PROJECT TITLE: RETAIL SHOPPING CENTER ZONE ATLAS/DRNG. FILE #: K-11/D-45  
EXPANSION  
 LEGAL DESCRIPTION: LOT 7A, BLOCK 2 YUCCA ADDITION NO. 2, ALBUQ. NM.  
 CITY ADDRESS: 139 COORS BLVD SW.  
 ENGINEERING FIRM: Lovelady & Associates CONTACT: Frank Lovelady  
 ADDRESS: 7408 Morrow Ave. NE 87110 PHONE: 883-7973  
 OWNER: RUE'S PLUMBING & HEATING CONTACT: JOE RUE  
 ADDRESS: 143 COORS BLVD. SW PHONE: 836-1388  
 ARCHITECT: RICK BENNETT CONTACT: RICK BENNETT  
 ADDRESS: 1118 Park SW PHONE: 242-1859  
 SURVEYOR: Oliver Trujillo CONTACT: \_\_\_\_\_  
 ADDRESS: \_\_\_\_\_ PHONE: \_\_\_\_\_  
 CONTRACTOR: \_\_\_\_\_ CONTACT: \_\_\_\_\_  
 ADDRESS: \_\_\_\_\_ PHONE: \_\_\_\_\_

RE: REVISED DRAINAGE PLAN FOR RETAIL SHOPPING CENTER  
(K-11/D45) REVISION DATED FEBRUARY 19, 1988

RE: DRAINAGE PLAN FOR RETAIL SHOPPING CENTER  
(K-11/D45) ENGINEER'S STAMP DATED OCTOBER 7, 1987

GRADING AND DRAINAGE PLAN  
RETAIL SHOPPING CENTER EXPANSION  
139 COORS BOULEVARD, S.W.  
ALBUQUERQUE, NEW MEXICO

## GRADING AND DRAINAGE PLAN

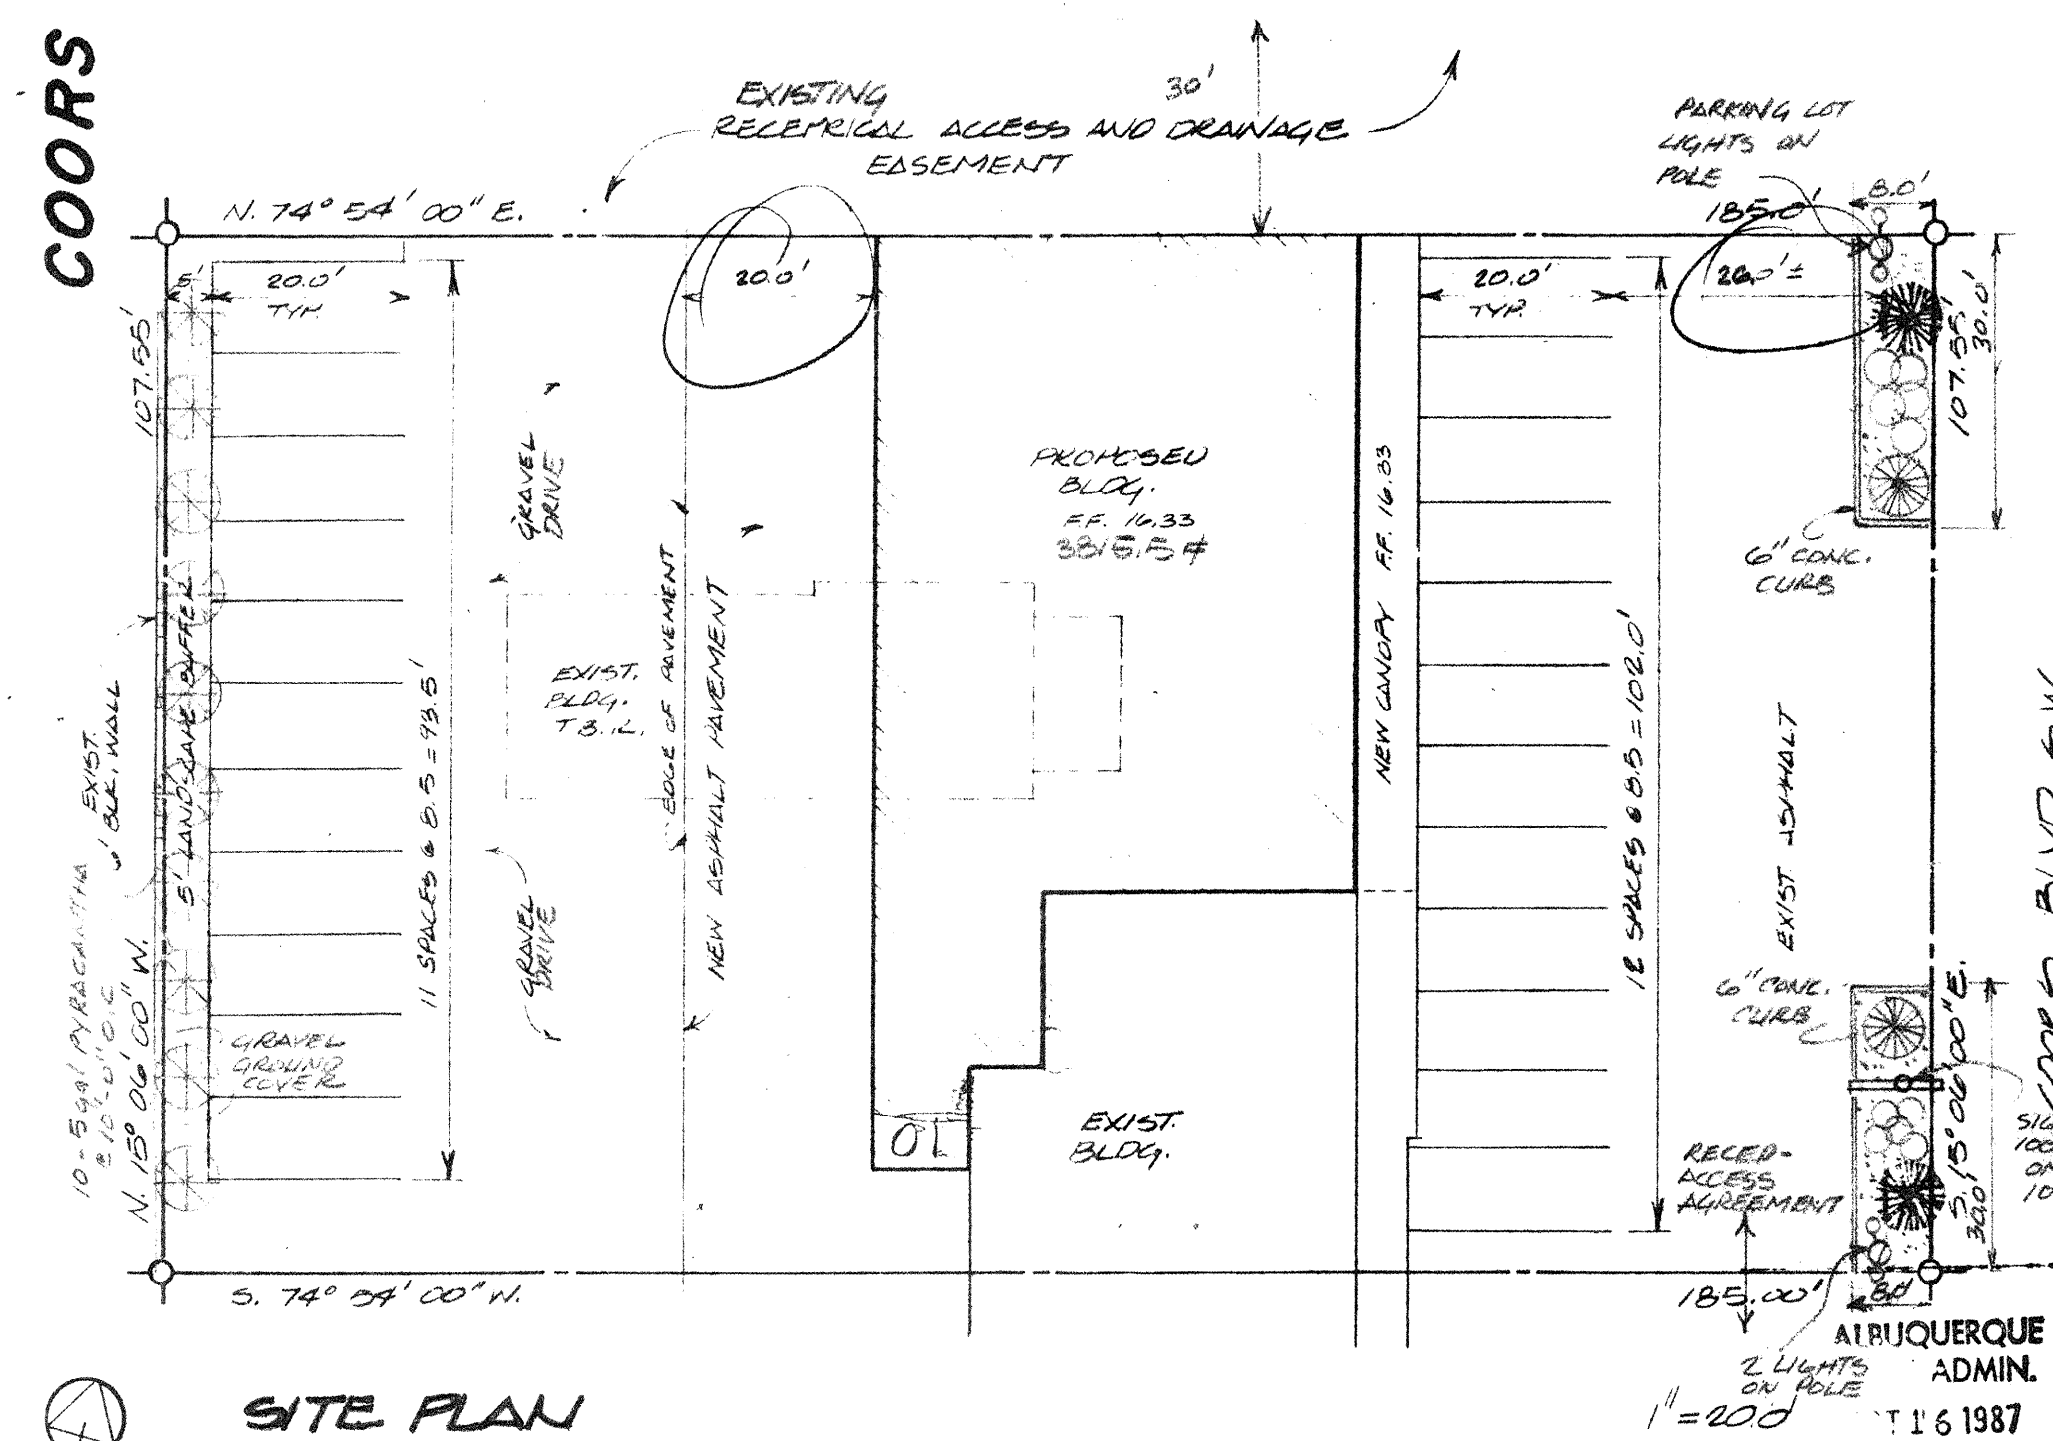
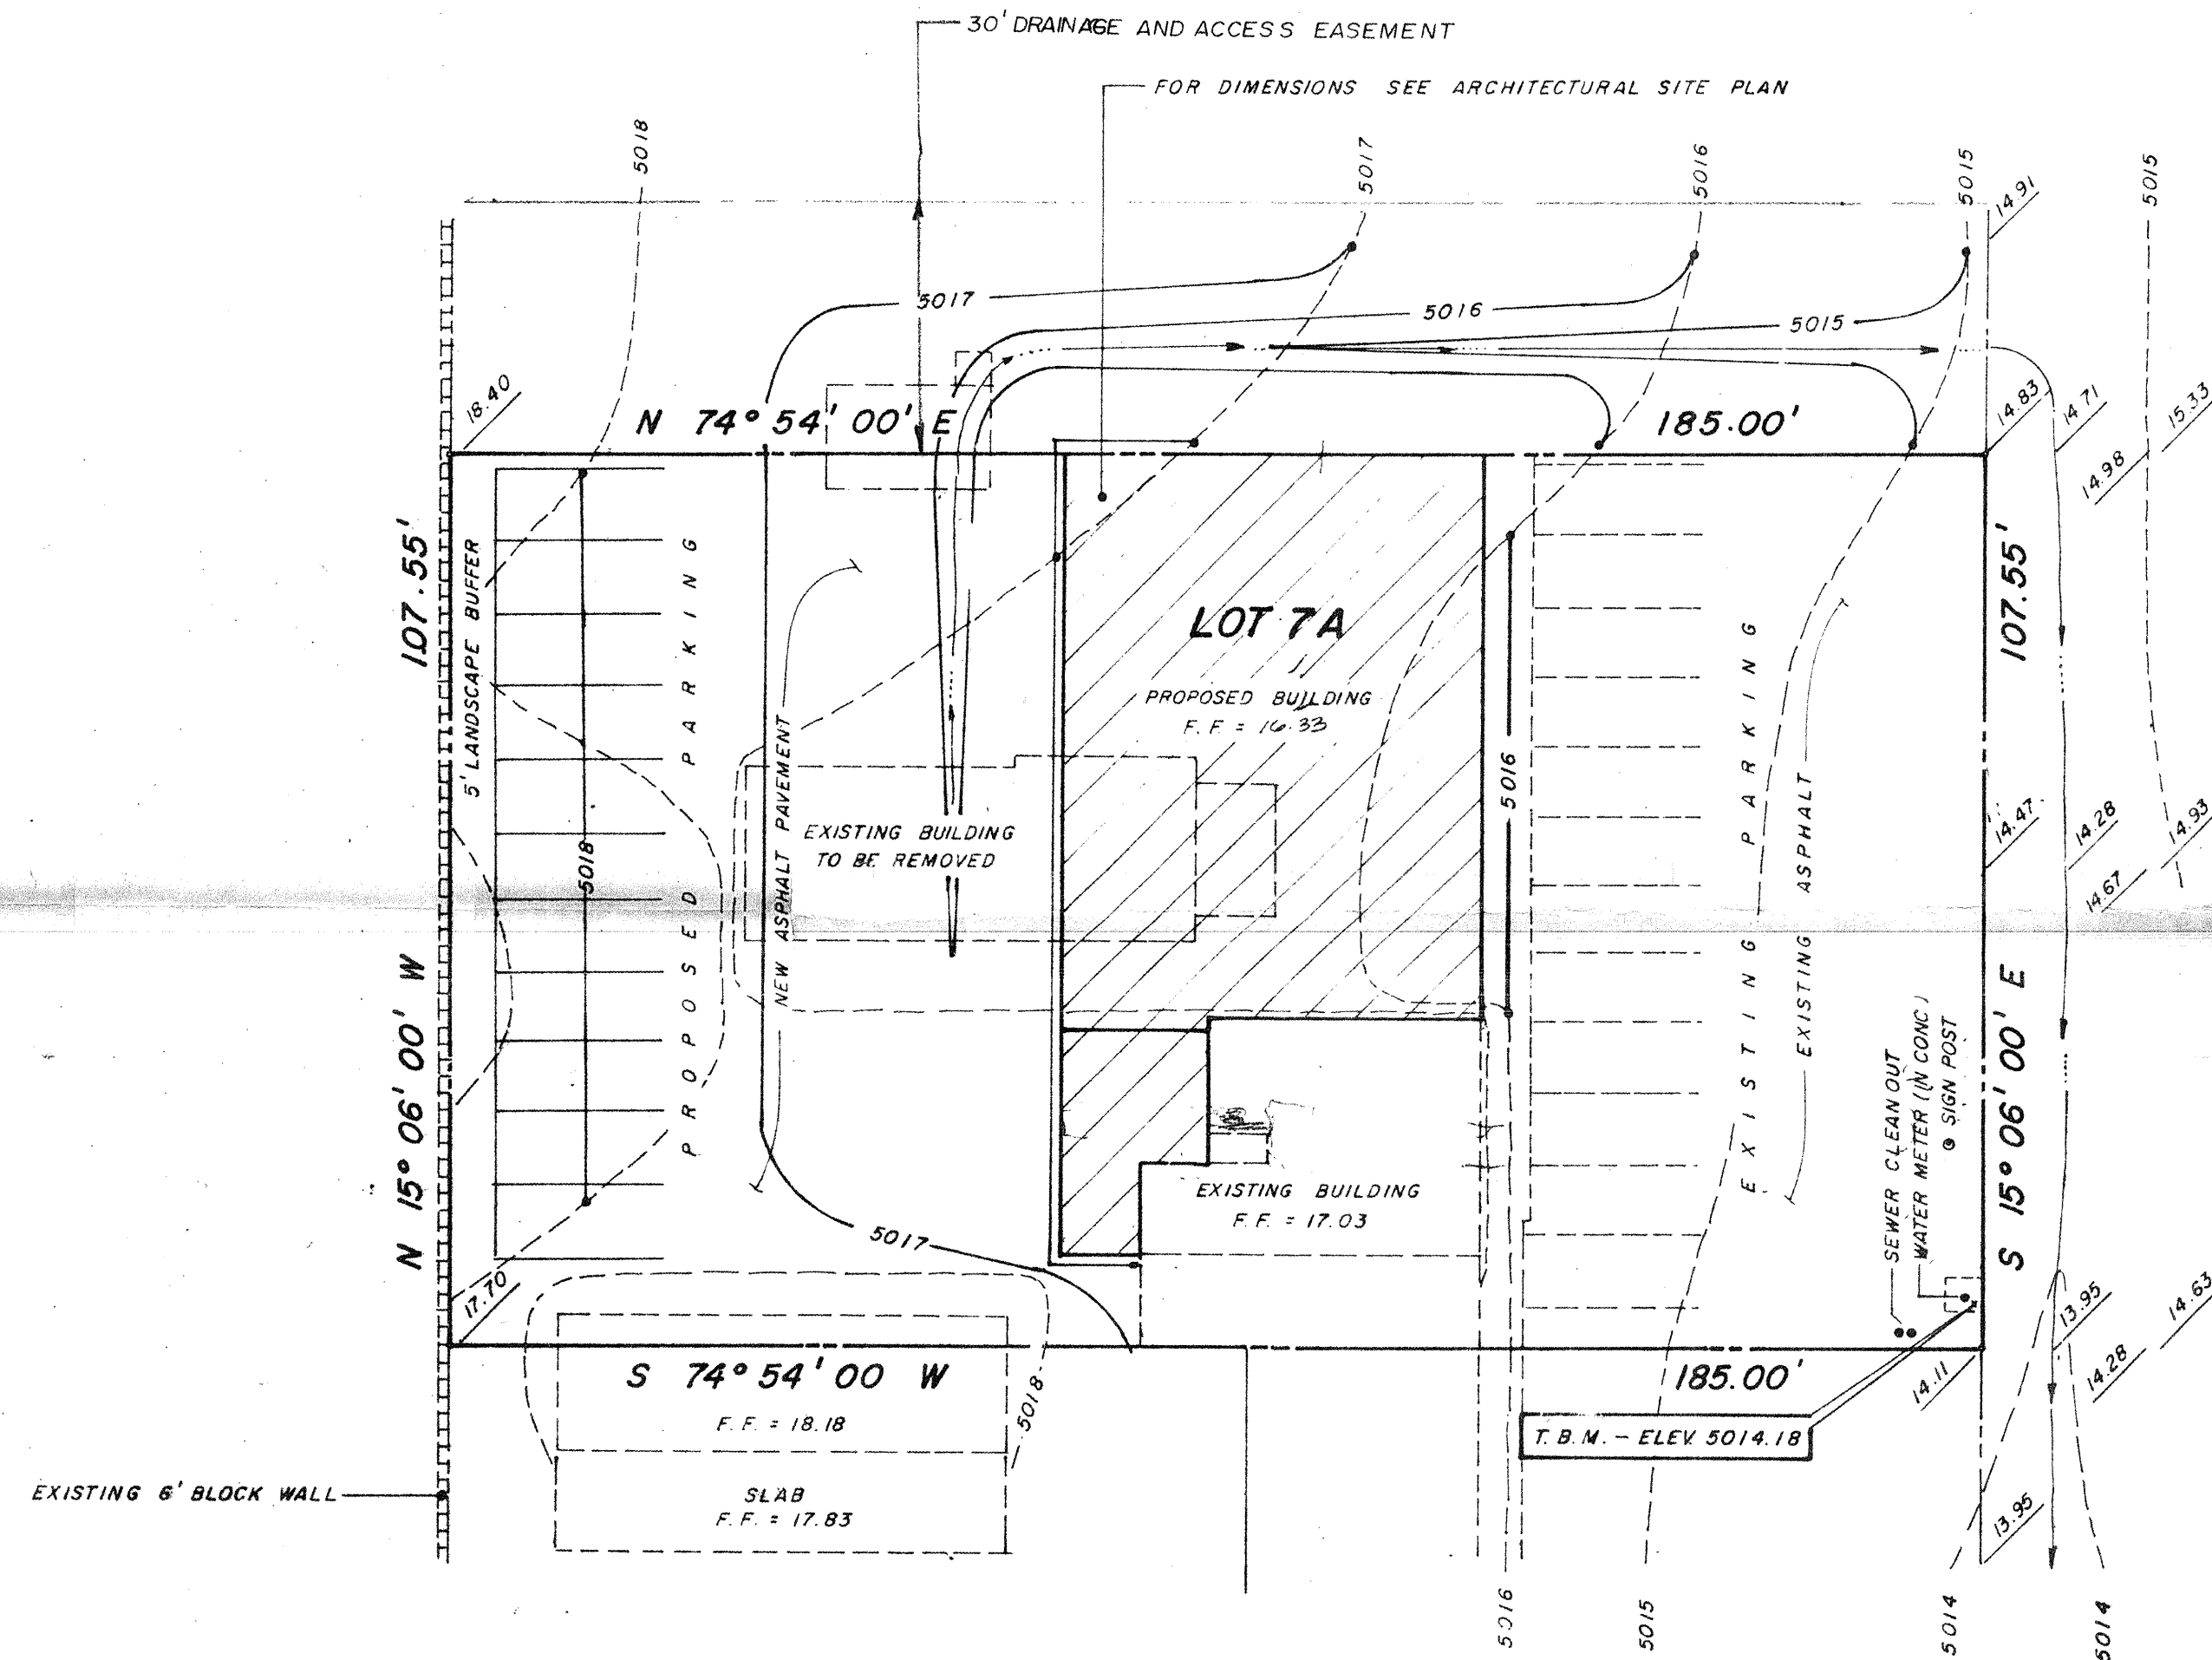
1. Drainage comments found within plan drawing do not reflect true conditions, please remove.
2. Easement will be needed for cross-lot-line drainage.

REVISED 2/19/88
